NOAA
FISHERIES

FWC Lionfish Exempted Fishing Permit Application Amendment

August 2019

Design

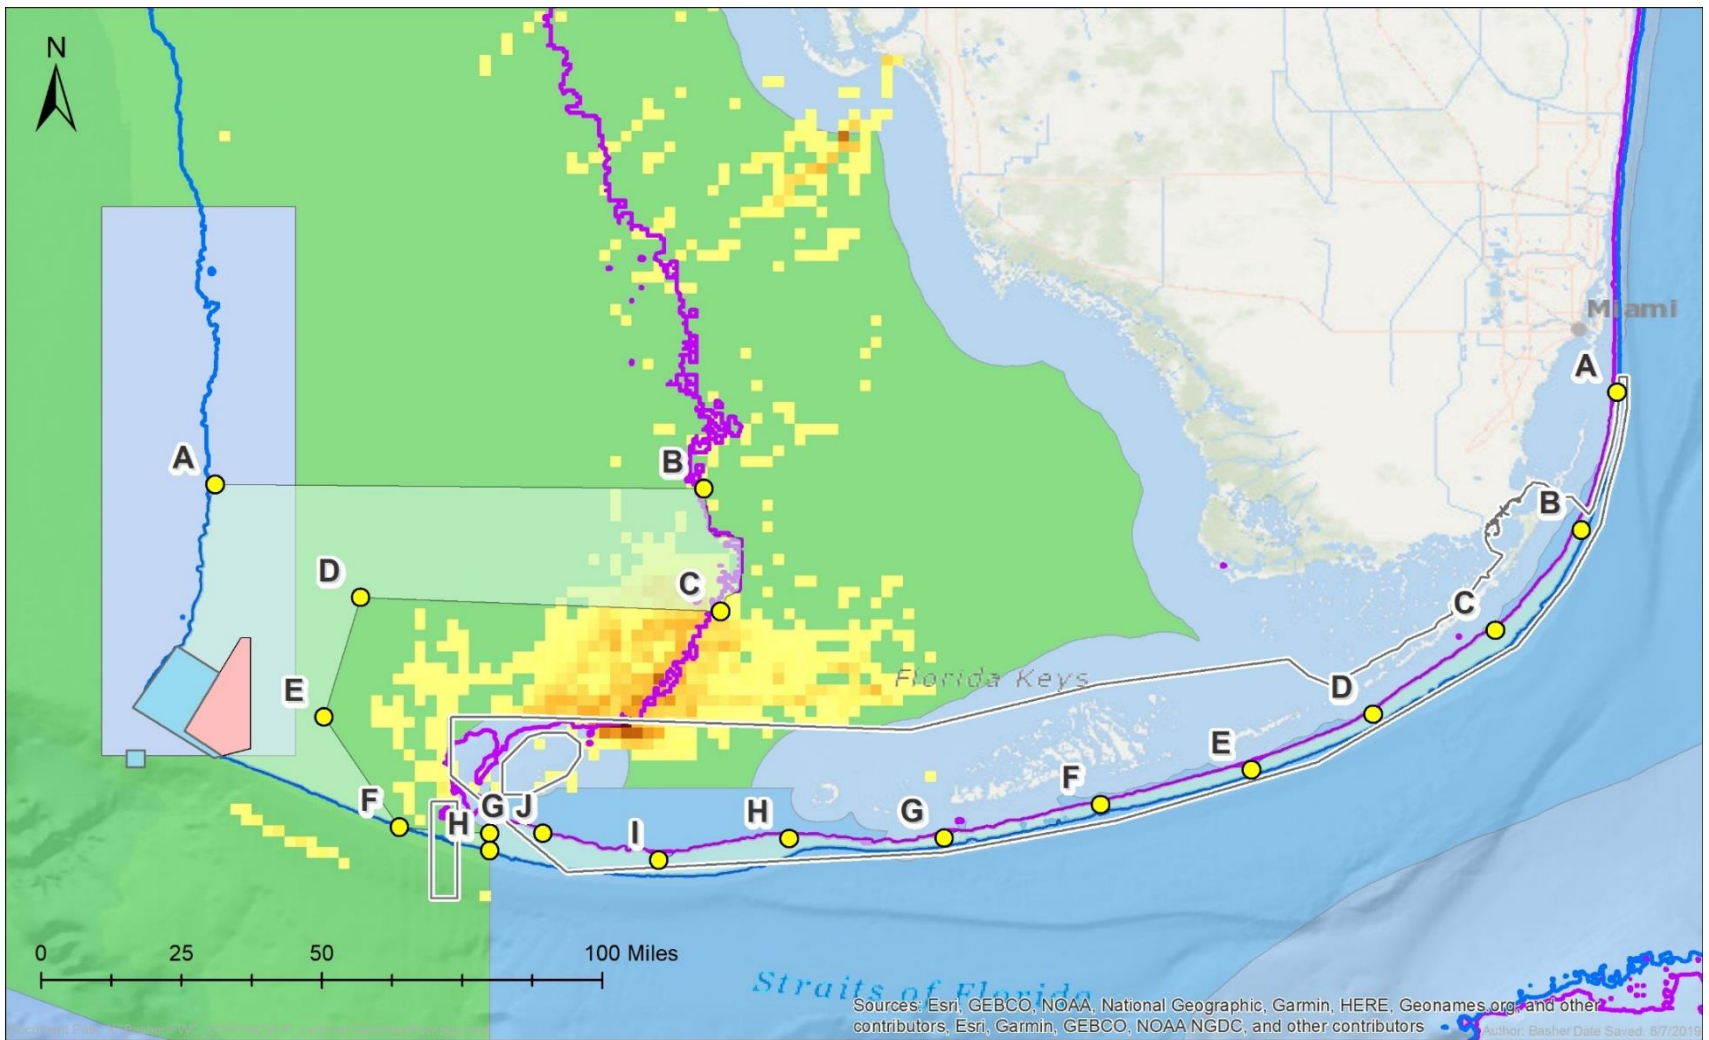
Standard and modified wire spiny lobster traps will be fished in a trawl – max 32 traps/trawl with no more than 2 vertical lines and buoys.

Traps will have various funnel and escape gap dimensions and locations. Some traps will be outfitted with lionfish optical recognition technology.
